REPORT AMENDED BY STAFF 1/26/89  
REPORT AMENDED BY STAFF 1/24/89  
**CITY PLANNING COMMISSION**

**APPLICATION:** A. Negative Declaration  
B. Plan Review to add 1,184+ sq. ft. to an existing 3,872 sq. ft. drive through restaurant on 1.1 developed acres in the Highway Commercial-Review (HC-R) zone.

**LOCATION:** 3773 Northgate Boulevard

APPLC. NO. P88-468 MEETING DATE January 26, 1989 ITEM NO. 35

# SITE PLAN

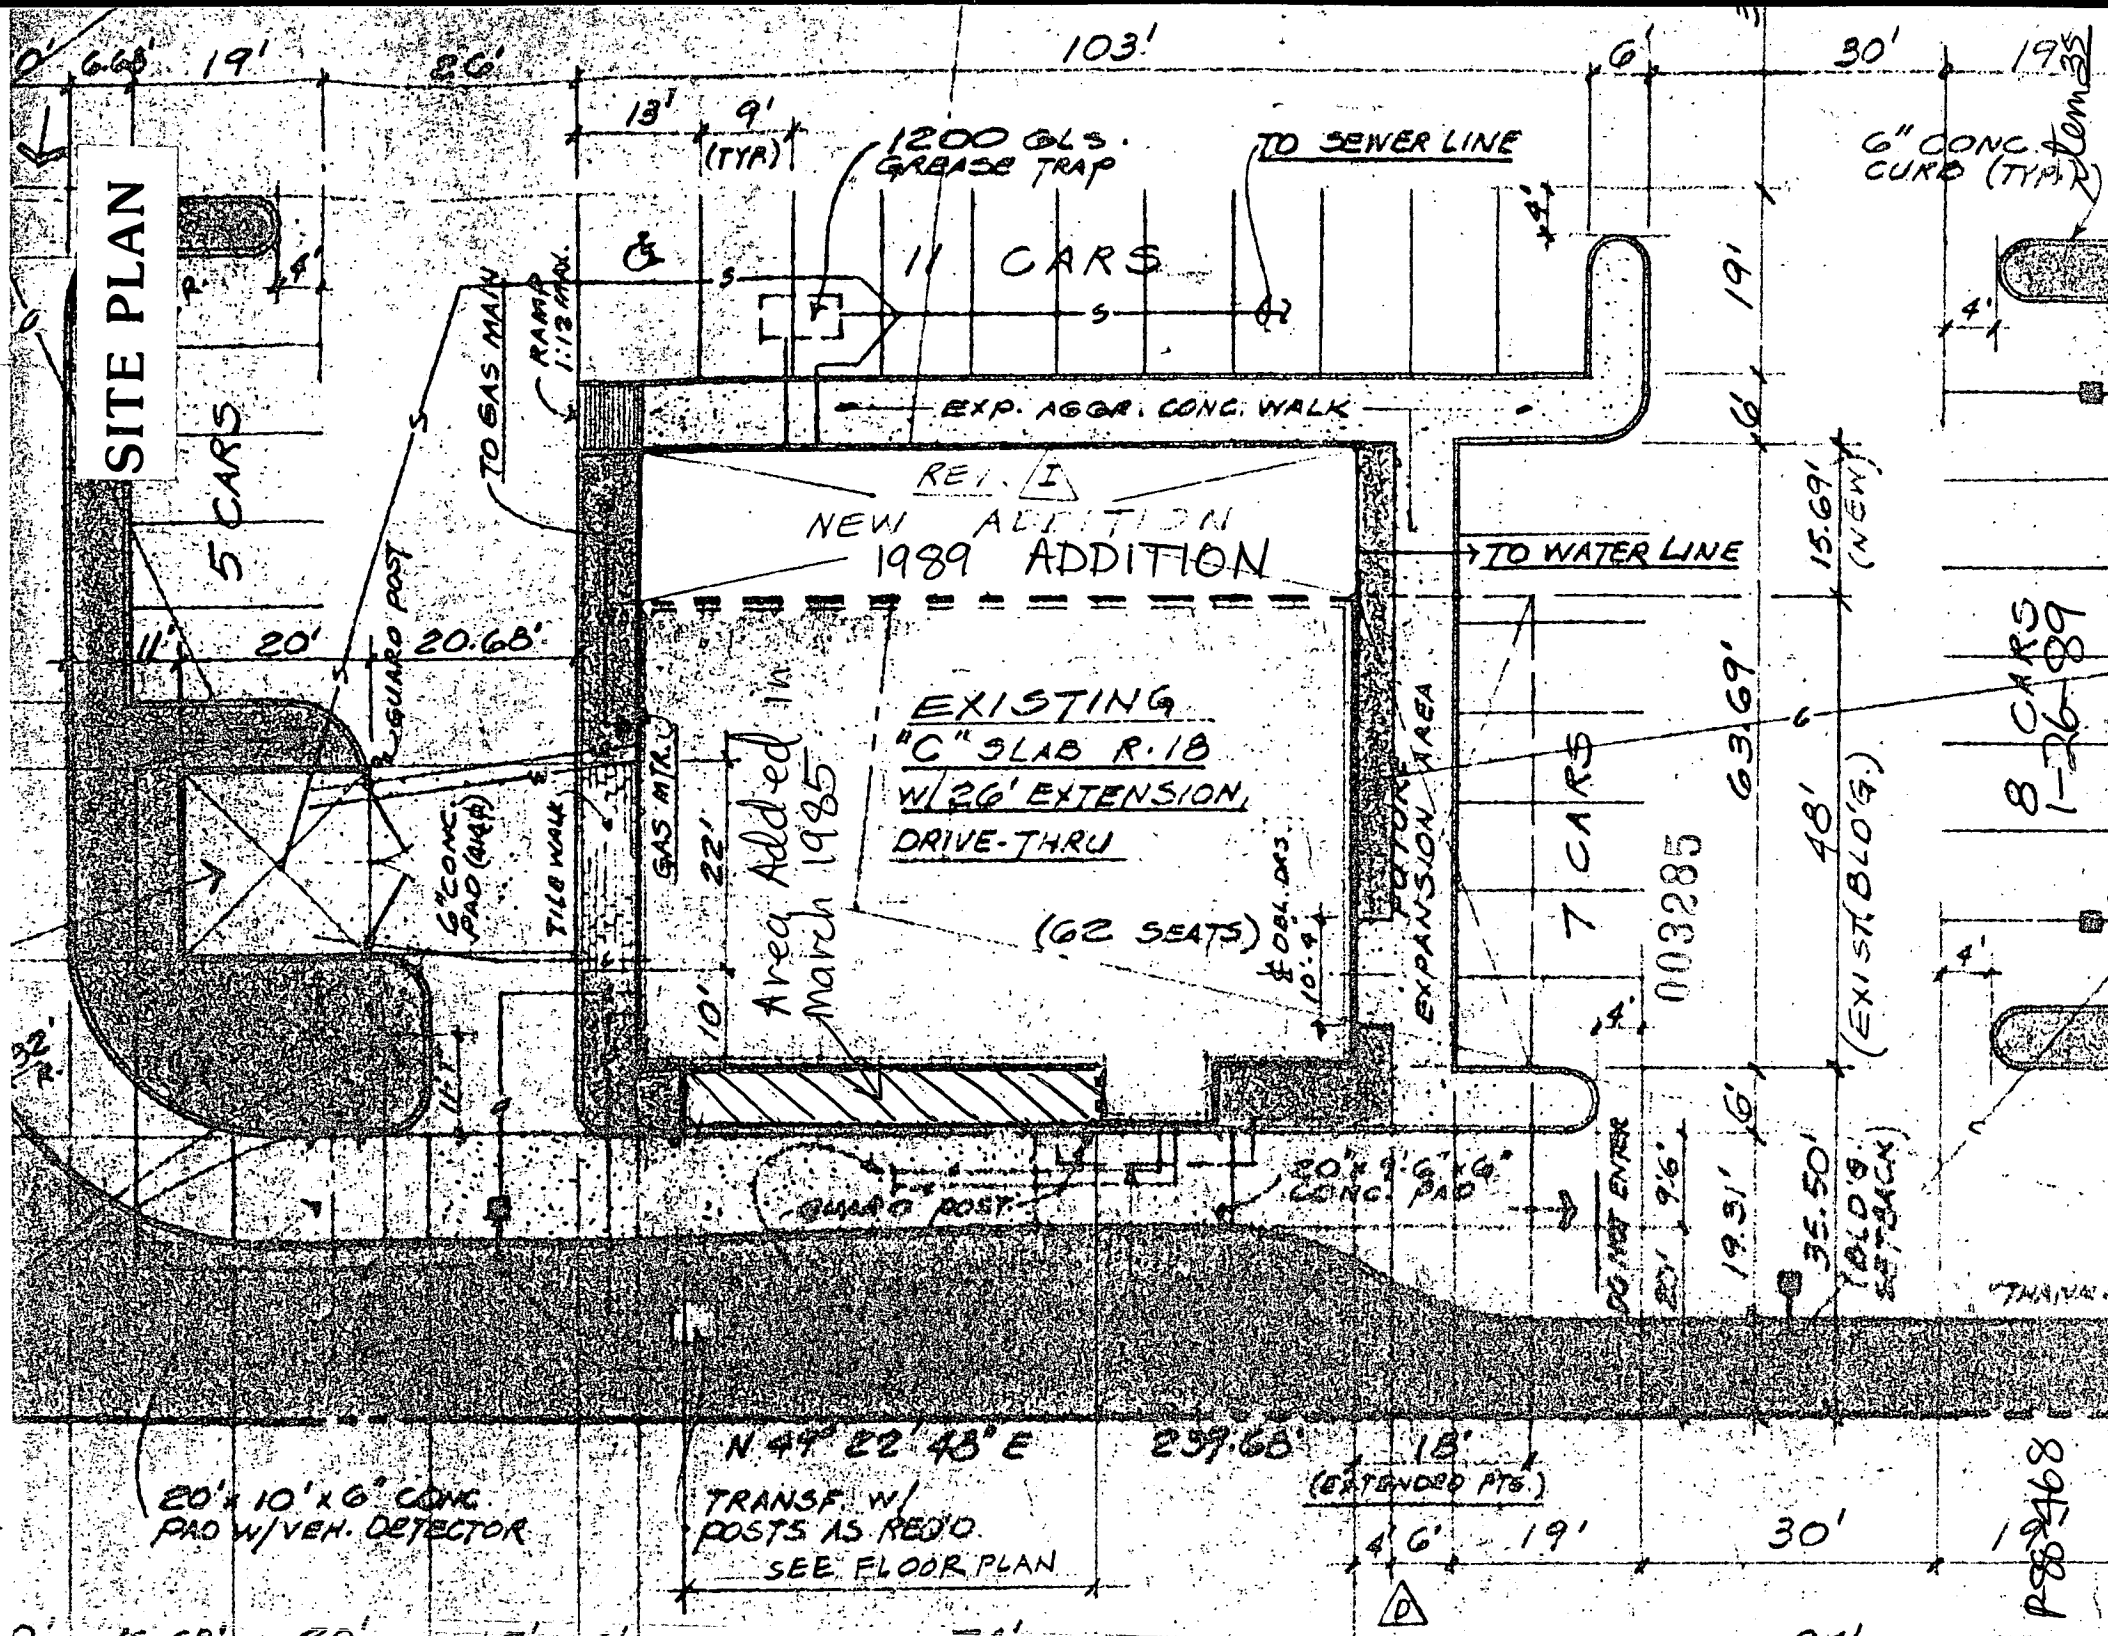
Now the applicant proposes to add 16 feet of new building into the existing 15 foot planter along the north elevation (one foot is accounted for the width of the existing wall which will be removed). The plans show no landscaping along the north elevation. Staff has discussed this with the applicant with the following results.

The parking lot backout maneuvering area is proposed to be reduced from the existing 30 feet to 26 feet in order to allow a landscape strip, four feet wide, adjacent to the building where shrubbery can be planted which is designated to reach a minimum four foot height. Staff notes that several well developed trees will require removal for the additional along with an established well designed landscape area. In lieu of the removal of the existing developed landscape area along the north elevation, staff recommends the applicant add two tree wells and plant 15 gallon specimen container trees in the north parking lot with ground cover. Since the parking lot was approved prior to the City Tree Shading Ordinance, it does not comply with the tree shading requirements. The addition of two tree wells is to be shown on the revised site plan with landscaping and irrigation. Reducing

the provided parking from 51 to 49 spaces still provides adequate parking for the seating expansion.

3. The Corporate Flag McDonalds is shall not be flown on the flag pole.
4. A revised landscape and irrigation plan shall show a minimum four foot planter along the north elevation adjacent to the addition area planted with vertical shrubbery which reaches a minimum four foot height. Two tree wells shall be added to the north parking lot. The revised landscape plan is to be reviewed and approved by Planning staff prior to issuance of building permits.
